Access Compliance Report

Public Rights-of-Way

(Curb Ramps)

Intersection ID: 25033	Main Street: ARBORETUM_VIEW	Cross Street: PINEVILLE-MATTHEWS_RD	Location: SW
ADA ID: 38128B3F95C0	Ramp Type: PerpDiag	Initial Pass/Fail: Fail	Overall Compliance: No
Severity Score: 22.5			
Codes/Mitigation Info/Possible Solution		Field Measurements/Component Compliance

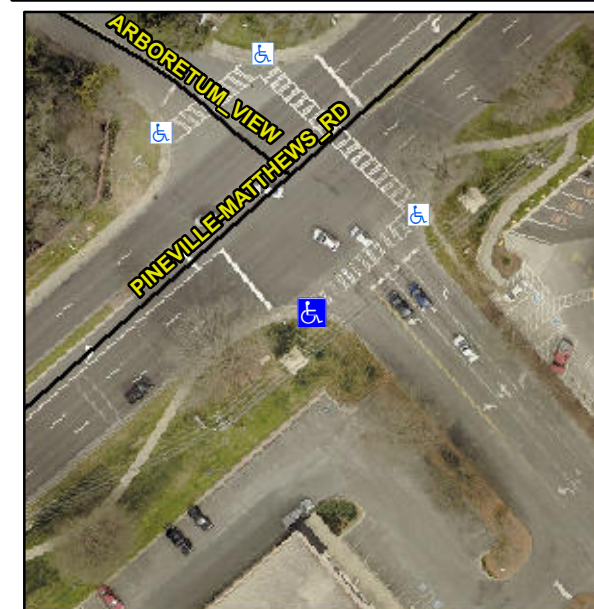
PROW/ADA:

R304.5.1, R304.2.2, R304.5.3

Compliance	Description	Data	Compliance	Description	Data
N/A	Ramp Length (in)	62.0	No	Ramp Slope (%)	10.0
No	Ramp Width (in)	38.5	No	Ramp XSlope (%)	3.4
N/A	Flare Type LT	N/A	N/A	Flare Type RT	N/A
N/A	Flare Slope LT (%)	N/A	N/A	Flare Slope RT (%)	N/A
N/A	Flare Traversable LT?	N/A	N/A	Flare Traversable RT?	N/A
N/A	Landing Length (in)	N/A	N/A	DWS Provided?	N/A
N/A	Landing Width (in)	N/A	N/A	DWS Contrast?	N/A
N/A	Landing Slope (%)	N/A	N/A	DWS Length (in)	N/A
N/A	Landing X Slope (%)	N/A	N/A	DWS Full Width?	N/A
N/A	Landing Curb? (Y/N)	N/A	N/A	DWS Offset (in)	N/A
N/A	Shared Landing?	N/A			
N/A	Gutter Ponding?	N/A	N/A	Gutter Slope (%)	N/A
N/A	Gutter Lip Ht (in)	N/A	N/A	Gutter X Slope (%)	N/A
N/A	Painted X Walk1?	Yes	N/A	Painted X Walk2?	No
	X Walk 1 Direction	To NE		X Walk 2 Direction	To NW
N/A	X Walk 1 Width (in)	101.0	N/A	X Walk 2 Width (in)	N/A
	X Walk 1 Slope (%)	1.7		X Walk 2 Slope (%)	3.2
	X Walk 1 X Slope (%)	4.4		X Walk 2 X Slope (%)	1.7

Remove & Replace Curb Ramp With Two New Directional Ramps or Equivalent.
